**Chittaranjan National Cancer Institute(CNCI)
Kolkata (W.B)**

AMENDMENT NO.-I

Project Name-Construction of Hospital Building, Residences, Hostels, etc including Associated Services and Operations & Maintenance during defect liability period at CNCI, Rajarhat, Kolkata

Tender No.-HSCC/CNCI/2015; dated 05.02.2015

MASTER PLAN

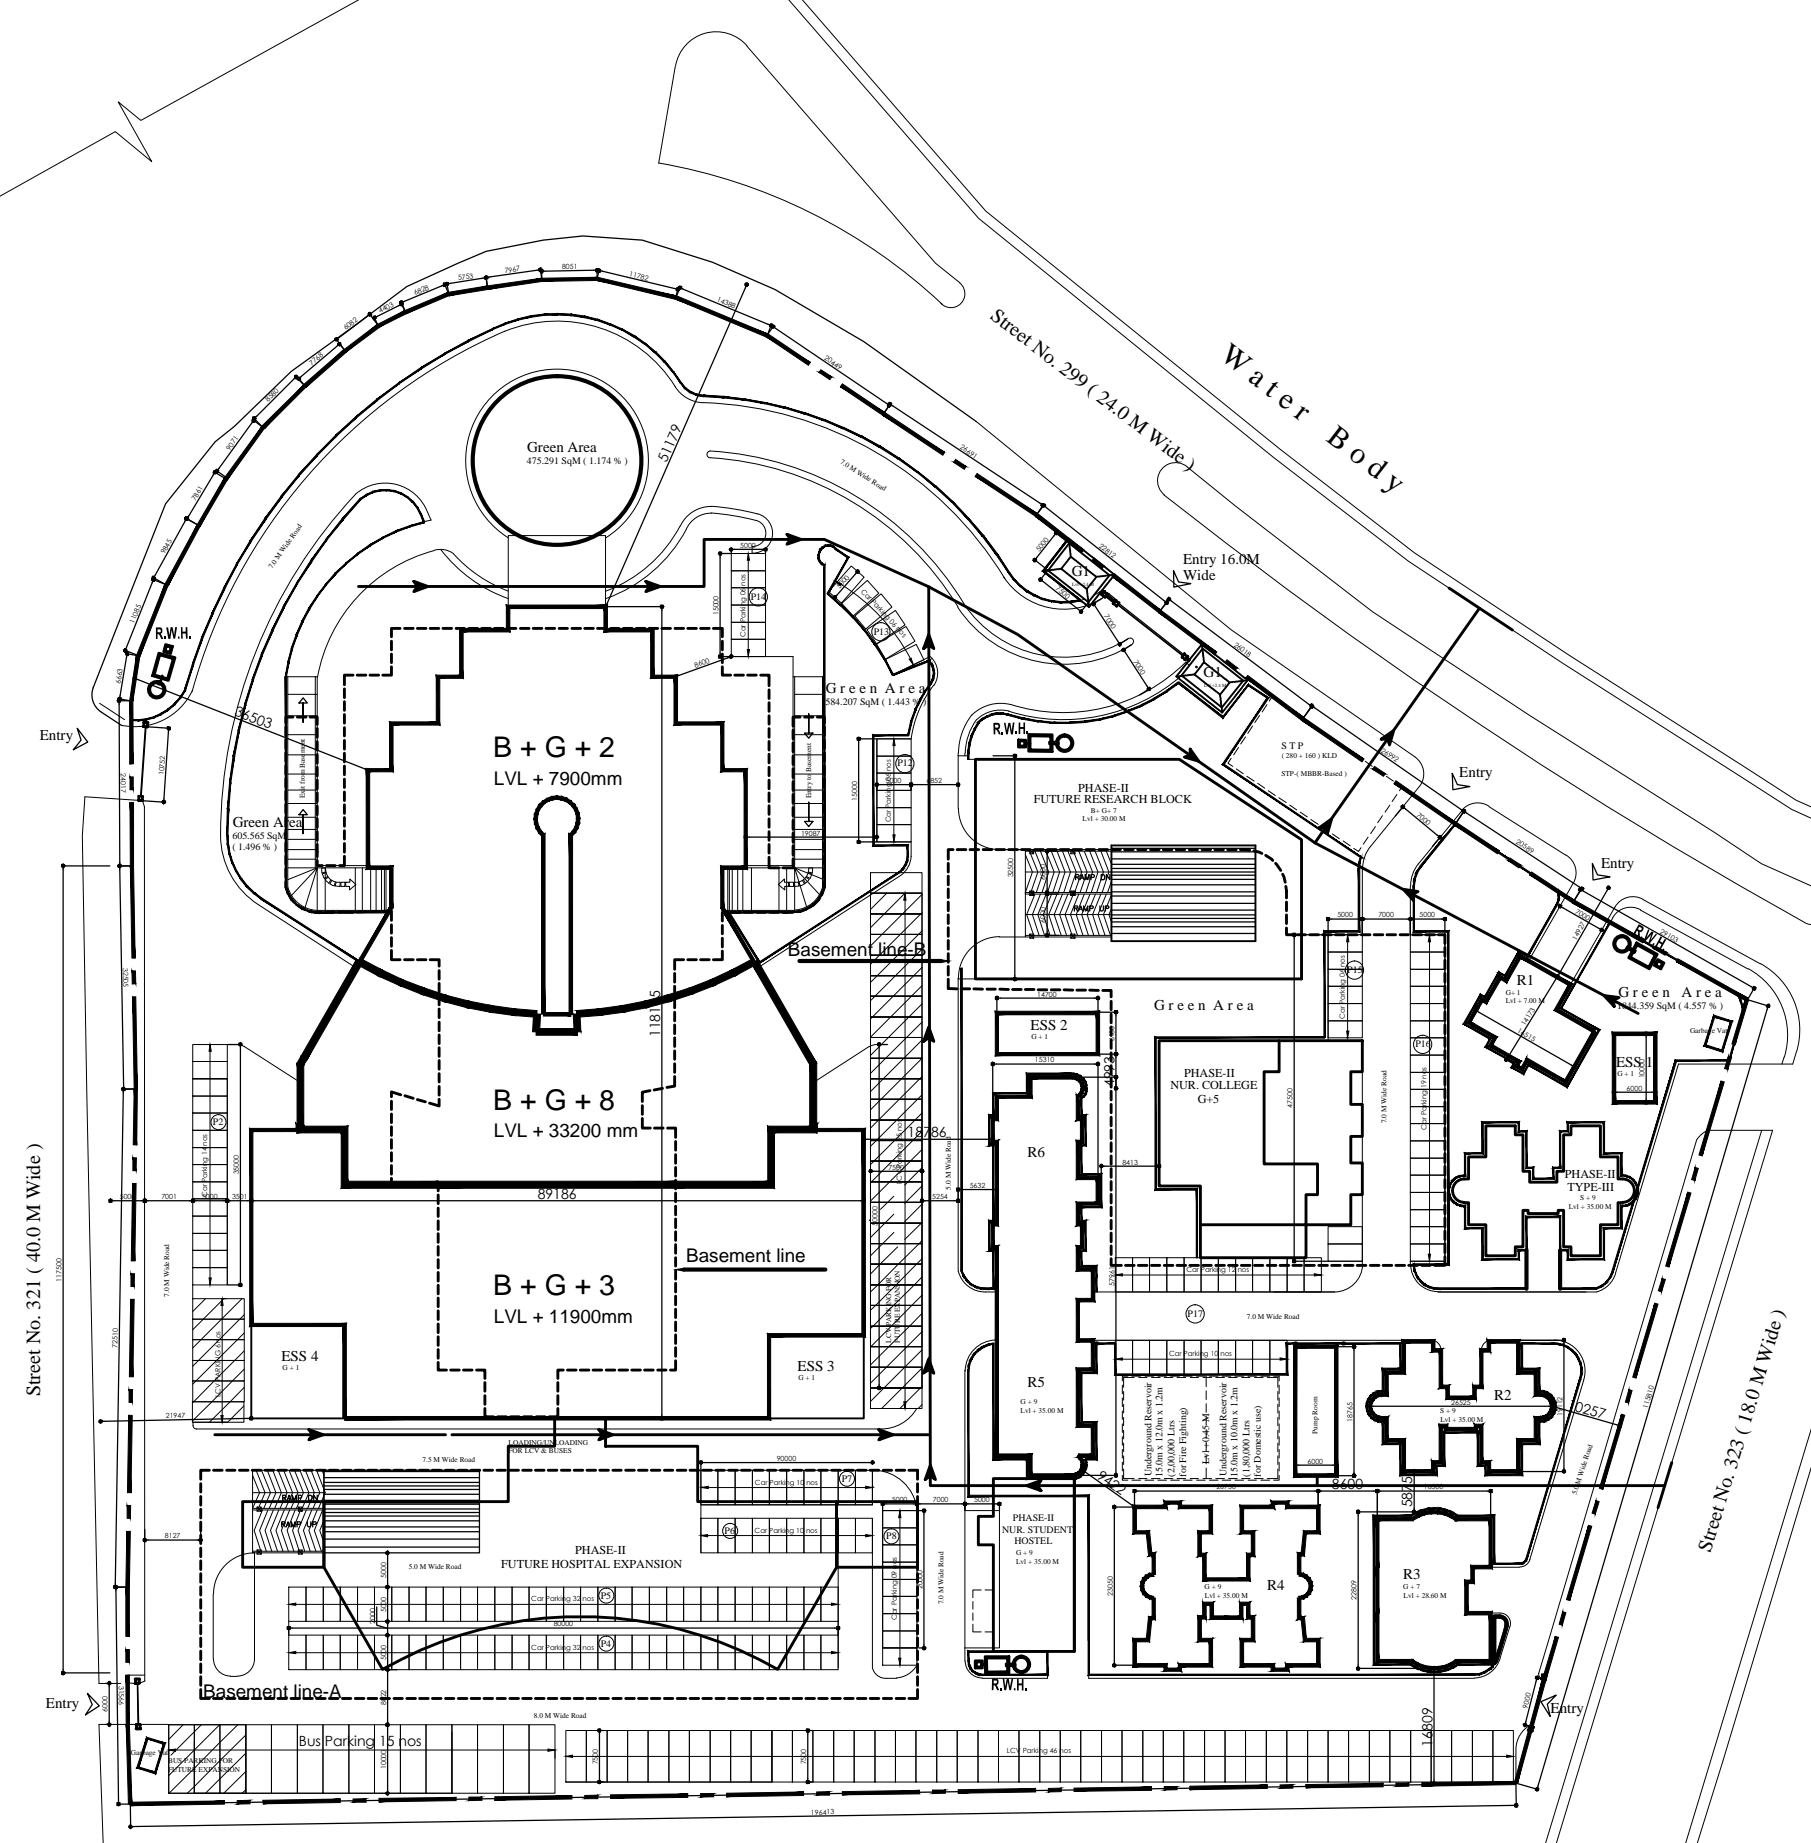
S.No	Clause, Section & Vol No	Description	Pre-bid Queries	Reply to Pre-bid Queries
20	General	Soil Investigation Report	Request you to provide the Soil Investigation Report with Borelog details.	Refer pg-13 of NIT Vol-I Clause 1.28 which states as under: "Tenderers are advised to inspect and examine the site and its surroundings and satisfy themselves before submitting their tenders as to the nature of the ground and sub-soil (so far as is practicable), the form and nature of the site, the means of access to the site, the accommodation they may require and in general shall themselves obtain all necessary information as to risks, contingencies and other circumstances which may influence or affect their tender."
21	General	Area statement	Request to provide building wise total area statement	Detail Drawings have been Provided along with Tender Documents
22	General	Drawing	Please provide Drawing no HSCC/CNCI/TD/MP/01 Master Plan.	Drawing No HSCC/CNCI/TD/MP/01 is uploaded as annexure-'A'
